SOUTHEAST LFA WELLFIELD PROJECT

GMP-2

SETM - Construction Package 1 & 6
September 4, 2024

SETM PACKAGE 1
ADDENDUM #1
08/14/2024

FIGURE #
STL-13

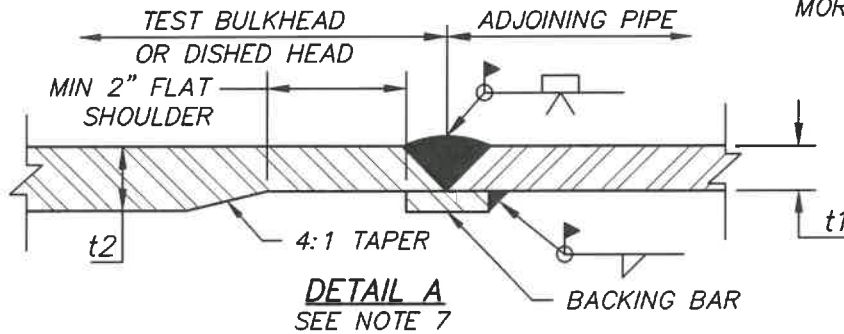
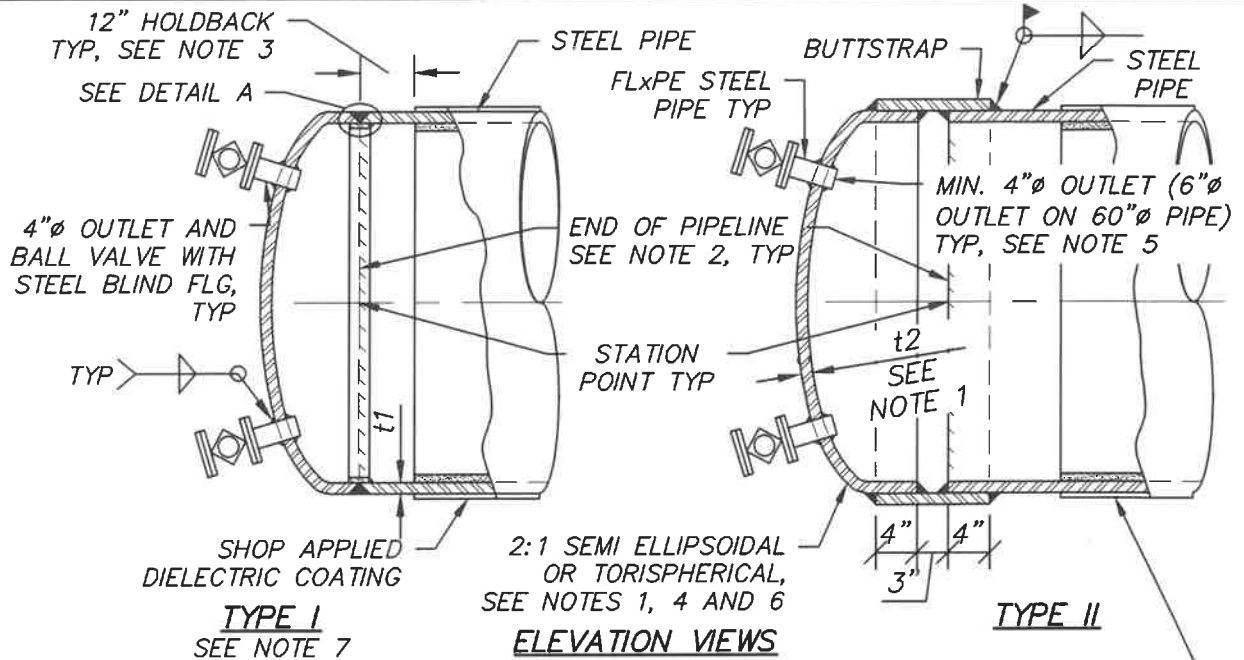
Question 1: On the plans for PRWC, sheet PP-151 calls out a test cap at the end of the line. It references a standard detail (STL-13) in keynote #2 for the test plug, however we can't find this detail in the plans. Please provide.

Response 1: The requested detail is attached to this document.

DOUBLE SWING GATE DETAIL

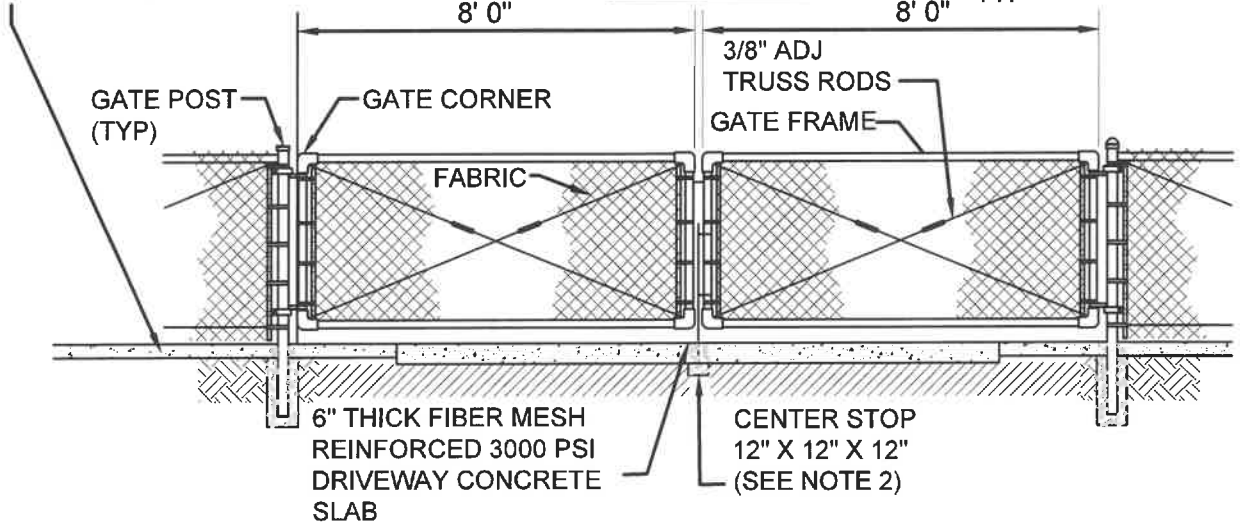
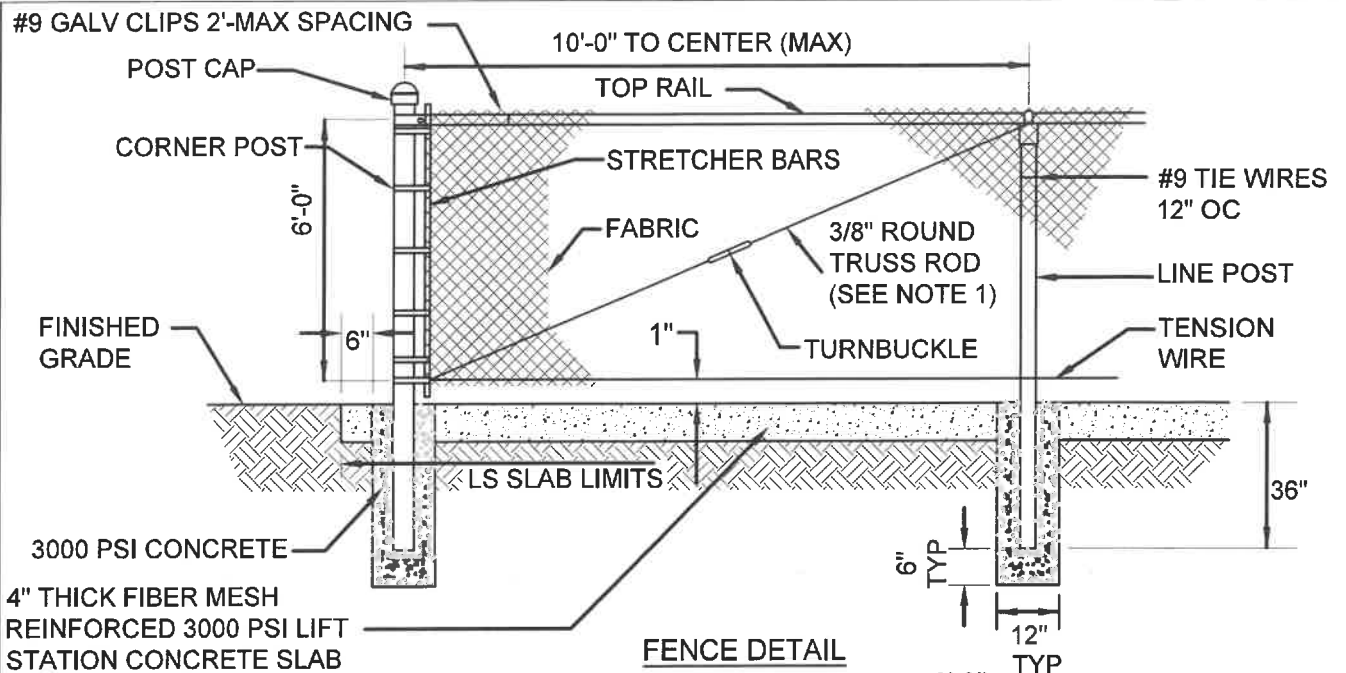
2. Refer to Dwg. C-001. The site plan shows a note, "proposed fence". Please provide a fence detail if this is required.

Response: The following typical fence and gate detail is to be used for the site. See attached detail.
